Re: Response to Engineering Review Letter dated November 4, 2014
TurboCAM - Map 234 / Lot 1.5
Barrington, NH

This letter is provided in response to the engineering review letter provided by DuBois & King, Inc., dated November 4, 2014. Please find enclosed the following:

GRADING, DRAINAGE, UTILITIES & EROSION CONTROL PLAN

CONSTRUCTION DETAILS
prepared for
TURBOCAM
MAP 234, LOT 1.5
ROUTE 9 BARRINGTON, NH

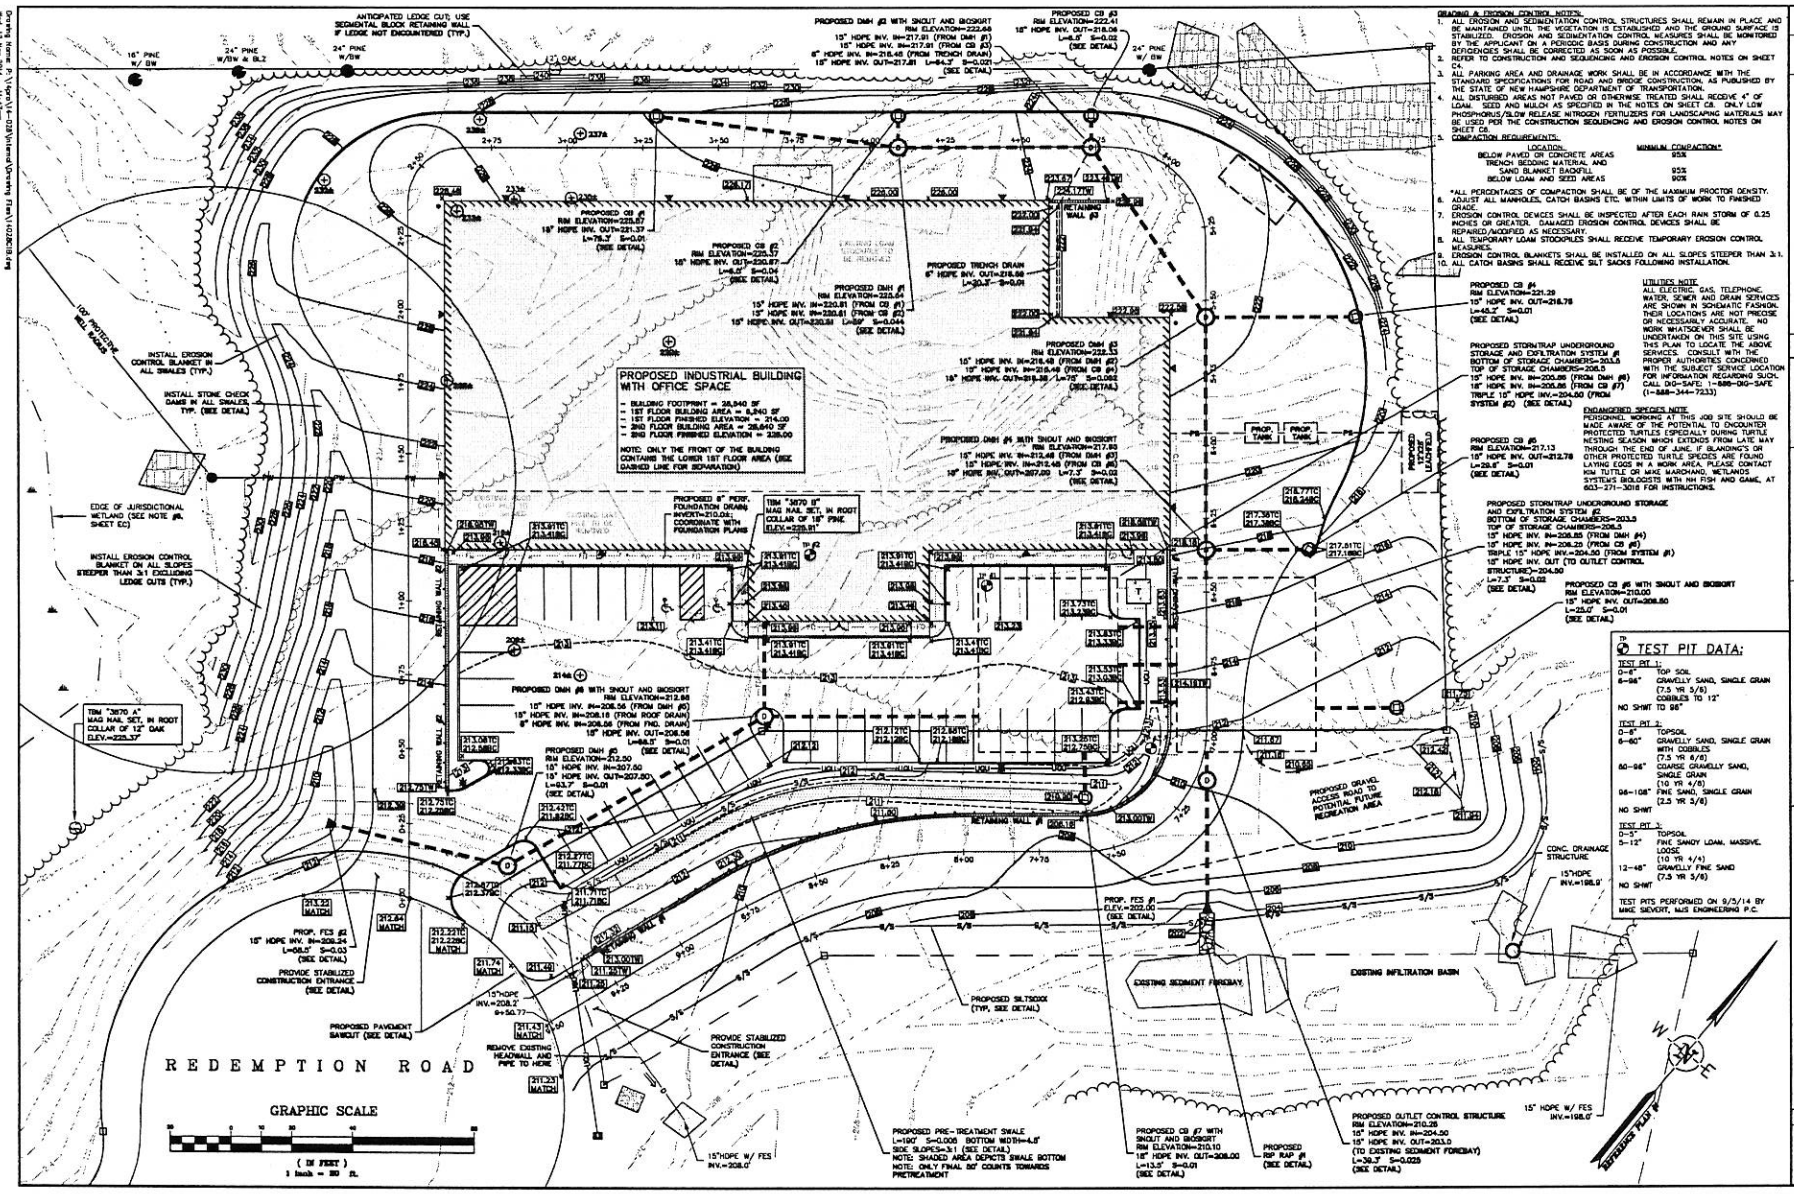
4. *The Drainage Report does not overlay the watershed boundary on a USGS quadrangle map. We were unable to confirm the watershed delineation.*

Refer to the enclosed map.

DRAIN MANHOLE

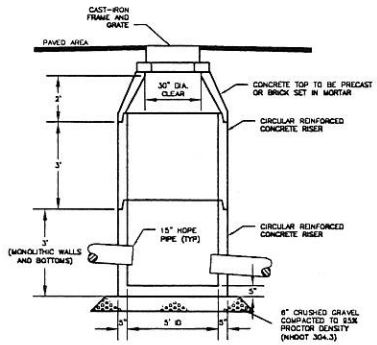
8. *The pre-treatment measure Snout and Bioskirt appears to be only shown at DMH No. 2. We recommend that this pre-treatment measure be at all drainage structures (i.e. DMH No. 4, No. 6 and CB No. 7) immediately prior to discharging collected stormwater to the StormTrap system.*

1. MINIMUM 37.5" SUMP REQUIRED FOR DMH #2, DMH #4, AND DMH #8 TO ACCOMMODATE SNOUT AND BIO-SKIRT
